Site Instruction

SI 24

PROJECT : Hampton Manor
PROJECT No : 1136.13
DATE : August 14, 2018

Title: Removal of Insulation behind Precast

1:20 A607

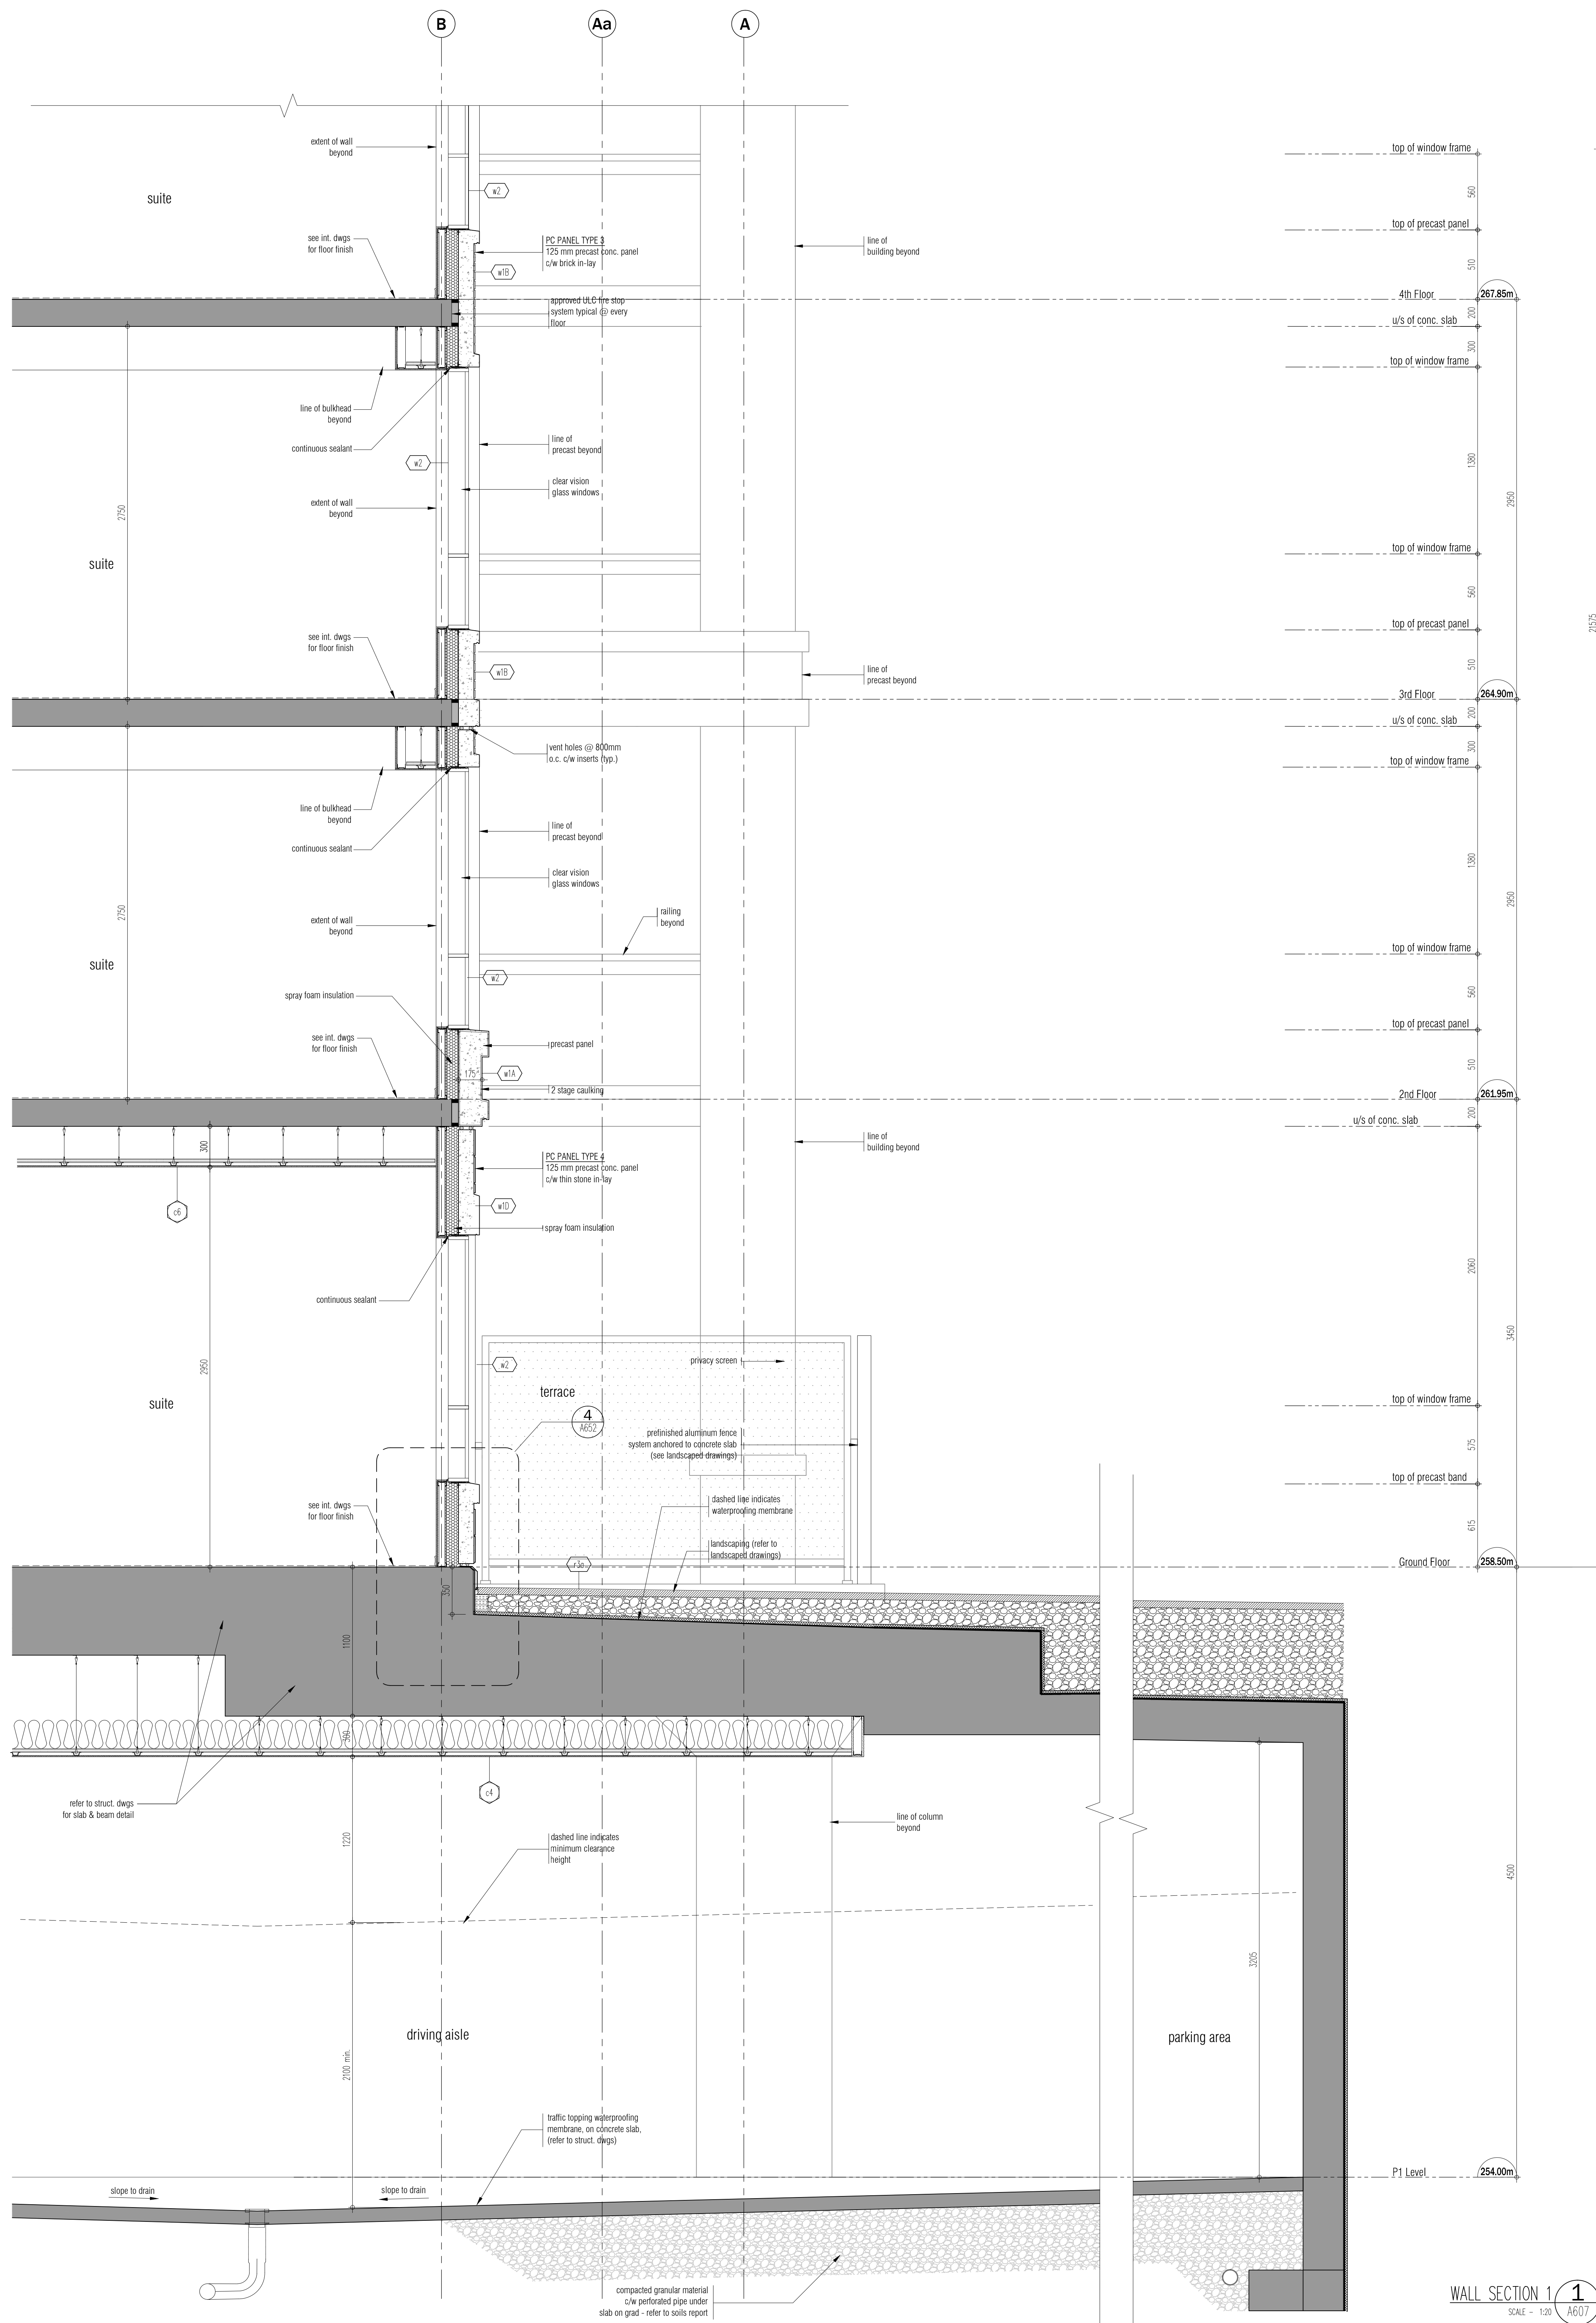
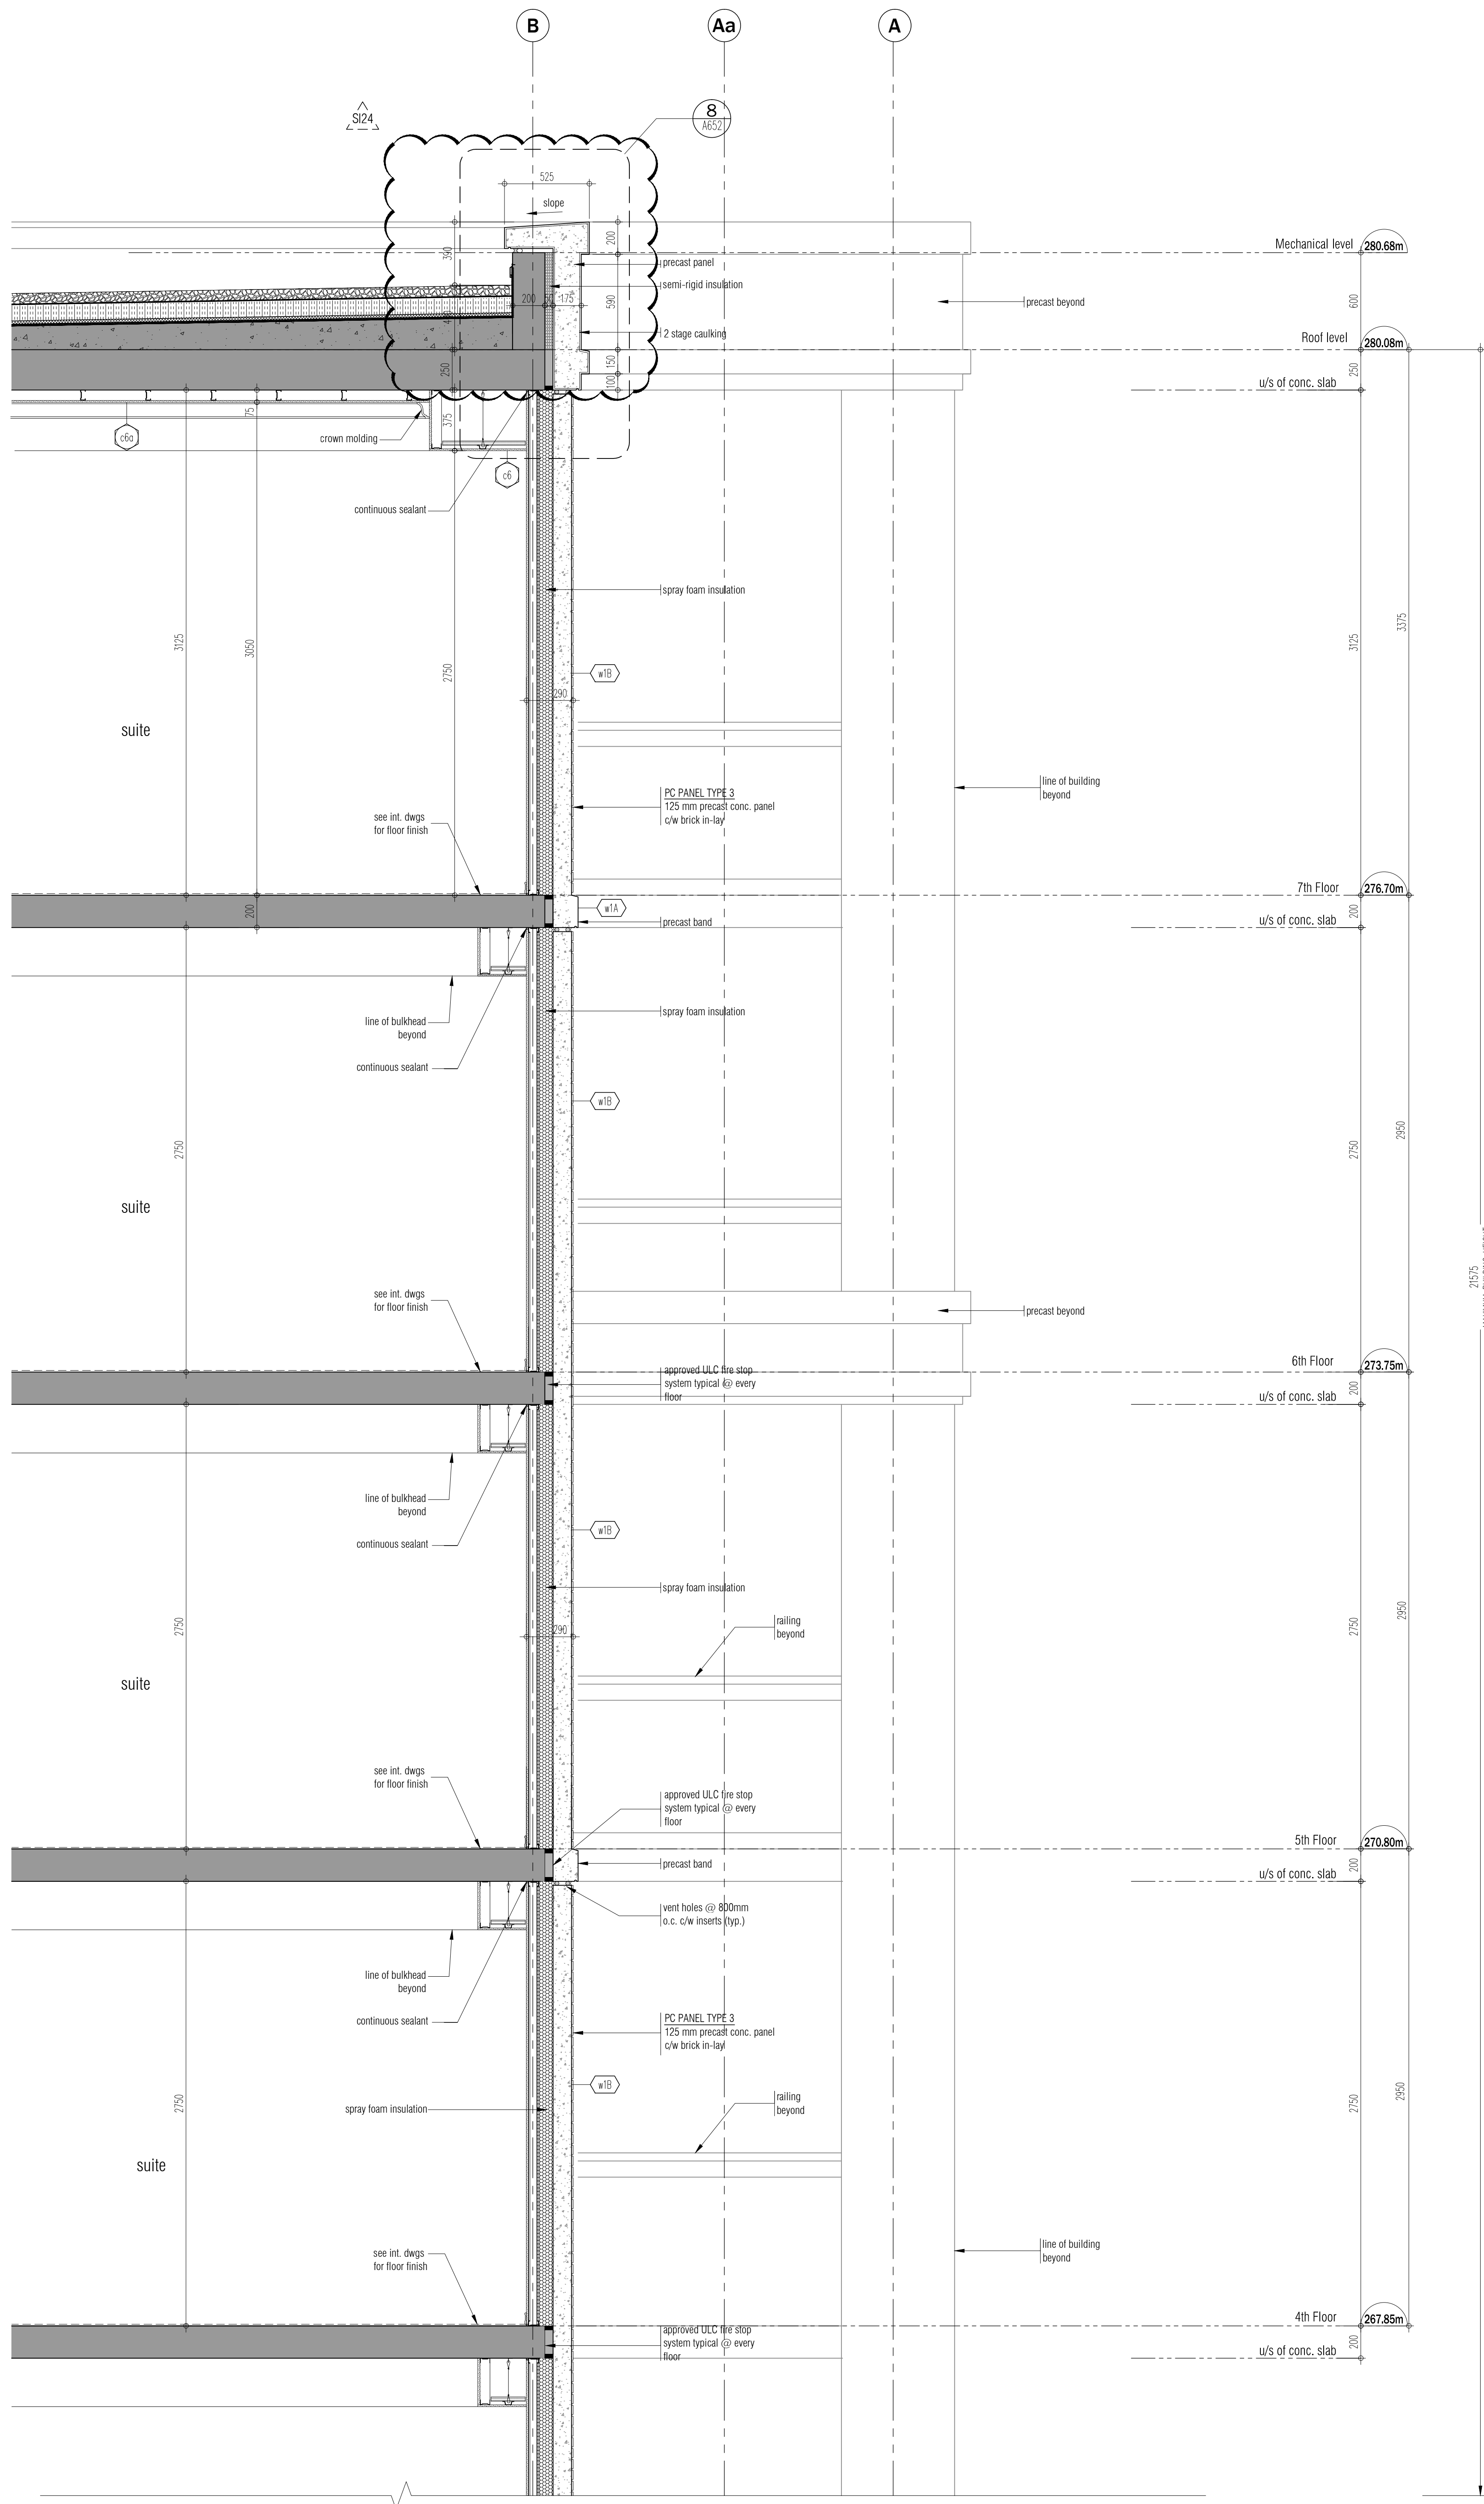
- Removal of insulation behind precast at terraces and roof.
